HP 7900A DISC DRIVE

RETROFIT KIT INSTRUCTIONS FOR UPPER HEAD ALIGNMENT PROBLEM

SPINDLE GROUND BUTTON KIT

SPINDLE GROUND BUTTON ASSEMBLY

FIGURE 1

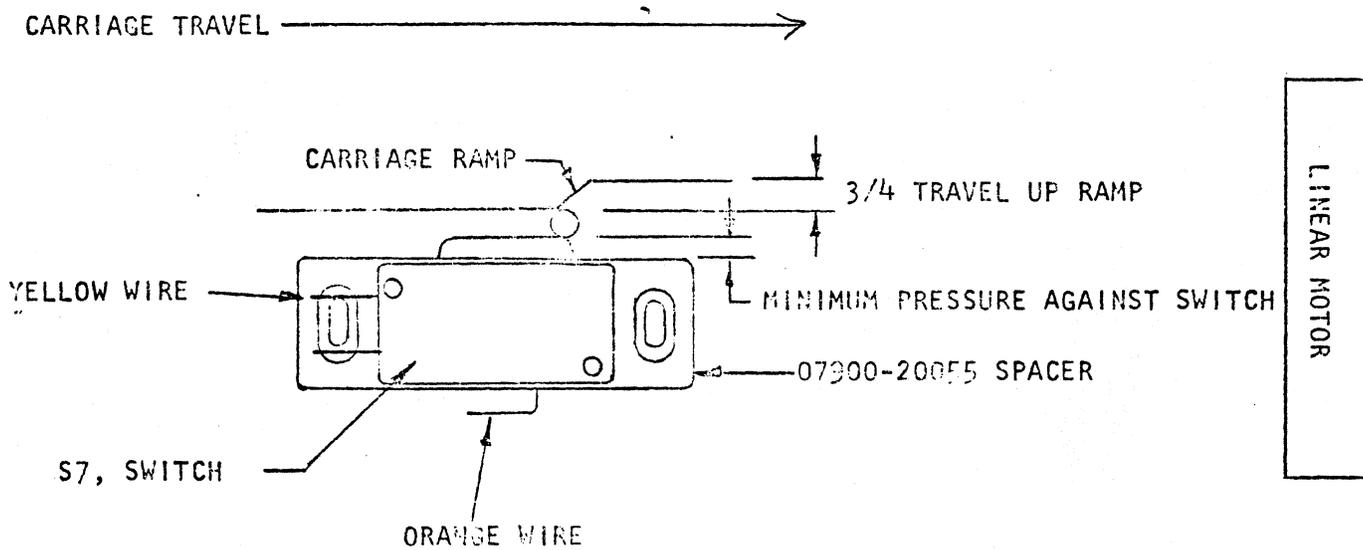
8. Adjust the switch to activate approximately 75% up the carriage switch cam slope (Fig.1). Tighten screws. When properly adjusted, switch should never bottom when heads are unloaded.

9. Reconnect wires to switch as shown in Figure 1.
10. Remove head clamps on heads 0 and 1. Install new head clamps (P/N 07900-20083) provided in kit.
11. Remove modesty shield from old cartridge receiver and install on new cartridge receiver (P/N 07900-60033) provided in kit.

FIGURE 2

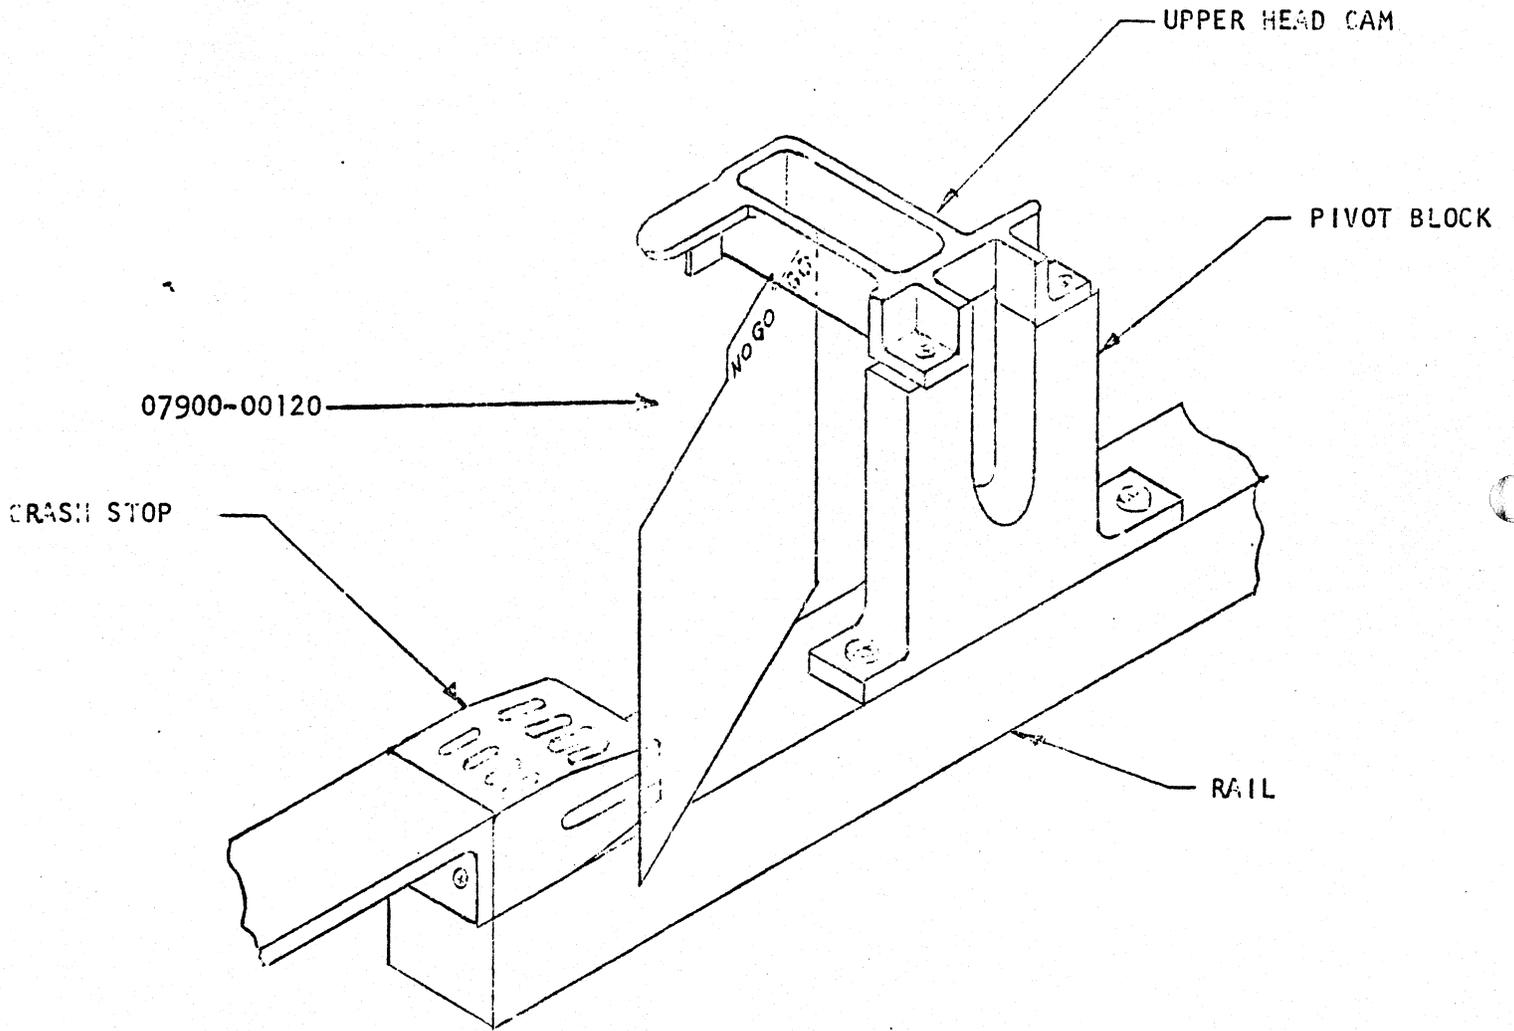
5. Install new upper head cam furnished with kit (P/N 07900-40044). Check height using Go-No-Go guage (P/N 07900-00120, Figure 2). Install shims (P/N 3050-0032) between upper head cam and the pivot block as required to obtain the correct height. Caution must be used to obtain the correct height to prevent head crashes.

Figure 1.

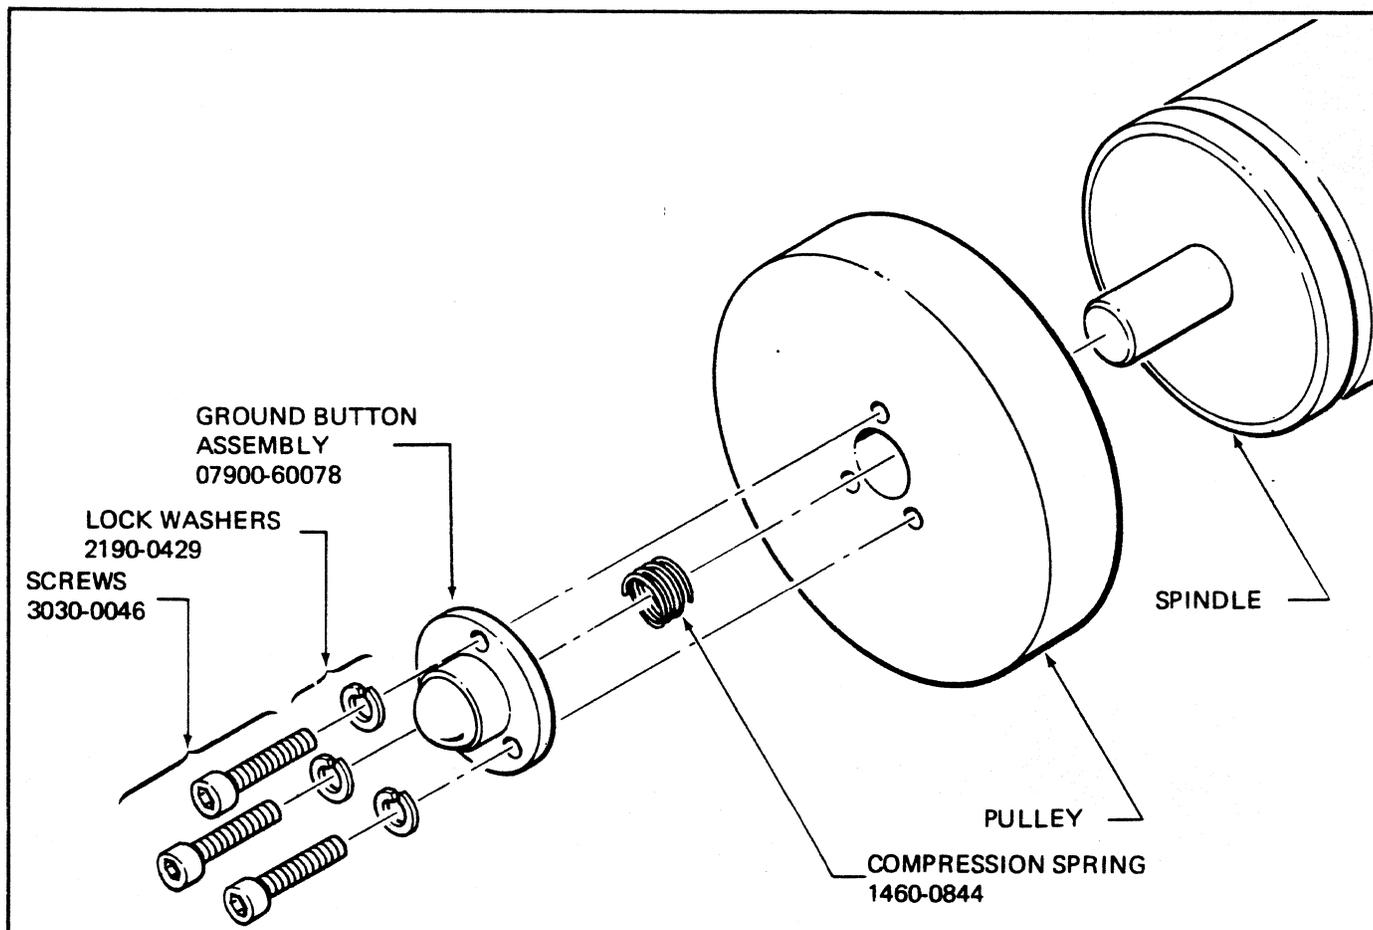
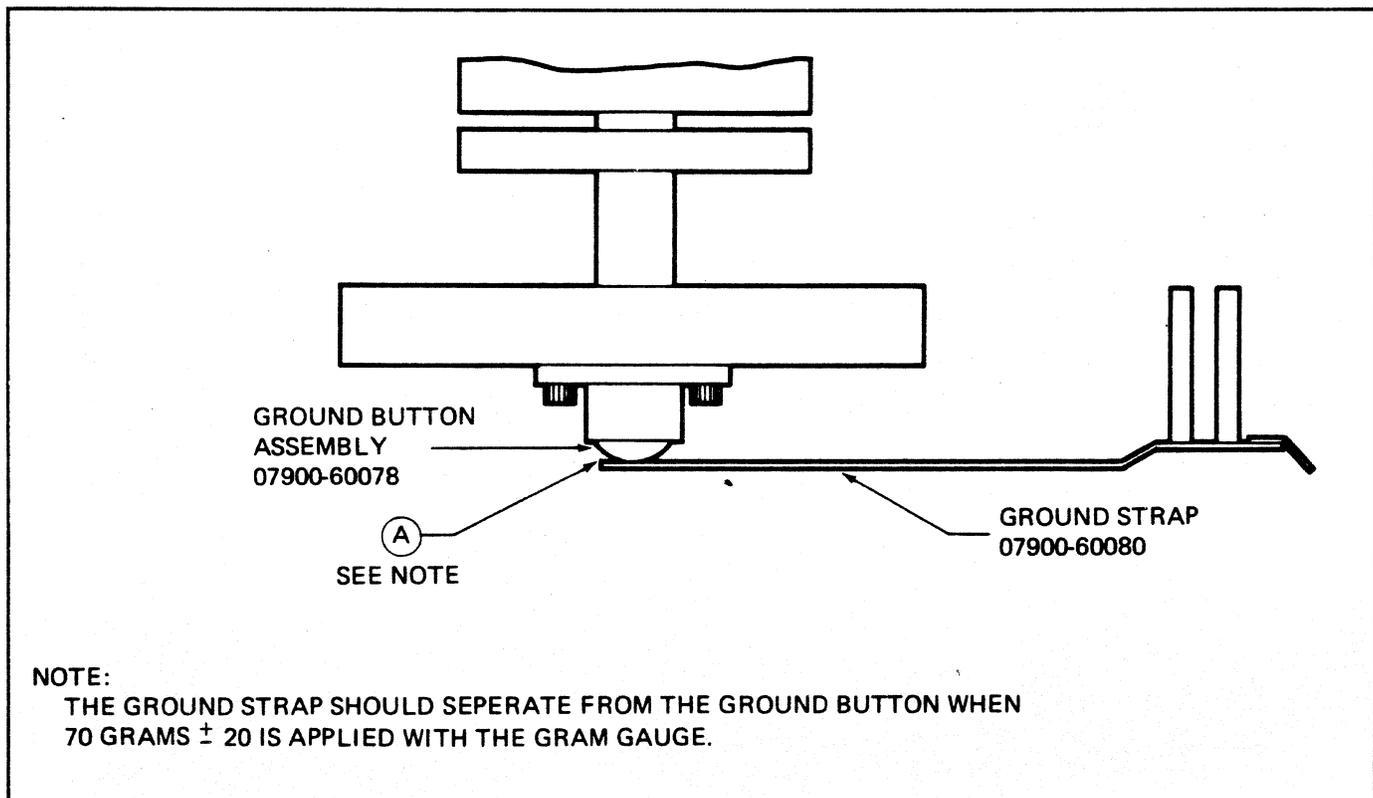
5. Remove ground button from spindle shaft end using an XACTO-KNIFE.
6. Remove Epoxy Residue using an XACTO-KNIFE and a fine grade of Emery paper.
7. Using Figure 1 as a Guide, reassemble pulley assembly.
8. Install Drive Belt.
9. Install new ground strap, and check for 70 ± 20 grams.
10. Reassemble drive and perform normal diagnostic tests.
11. Insert this service note (P-07900-60081-1) into customer manual.

THE GROUND STRAP SHOULD SEPERATE FROM THE GROUND BUTTON WHEN 70 GRAMS \pm 20 IS APPLIED WITH THE GRAM GAUGE.

Figure 1

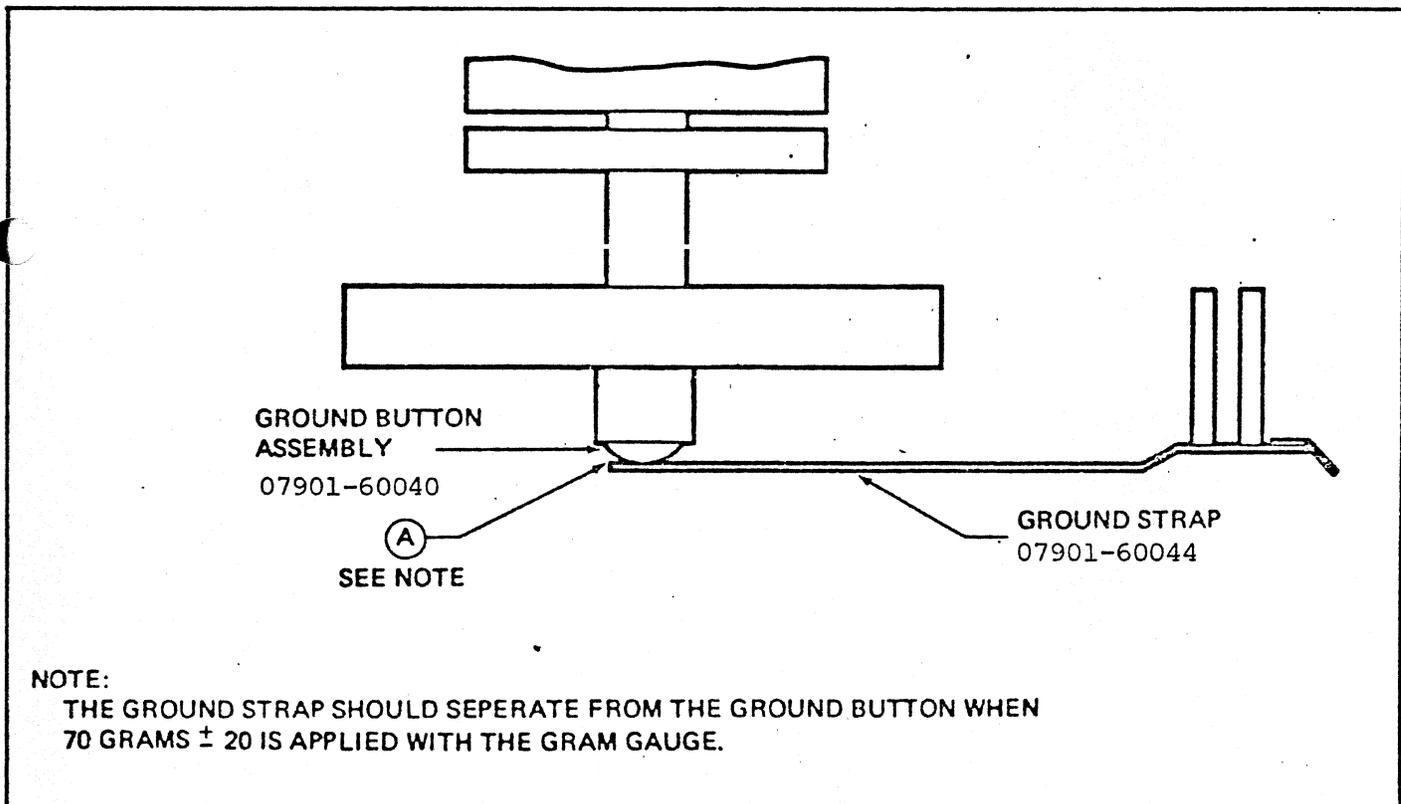
1. Remove power from the drive.
2. Remove ground strap (discard).
3. Remove ground button from spindle end.
 - a. Use an XACTO knife to remove old button.
 - b. Remove epoxy residue using XACTO knife and a fine grade of emery paper.
4. Install new ground button assembly.
5. Install new ground strap.
 - a. Use the gram gauge to assure the separation of the ground strap from the ground button when 70 grams + or - 20 grams is applied at point (A) . See Figure 1.
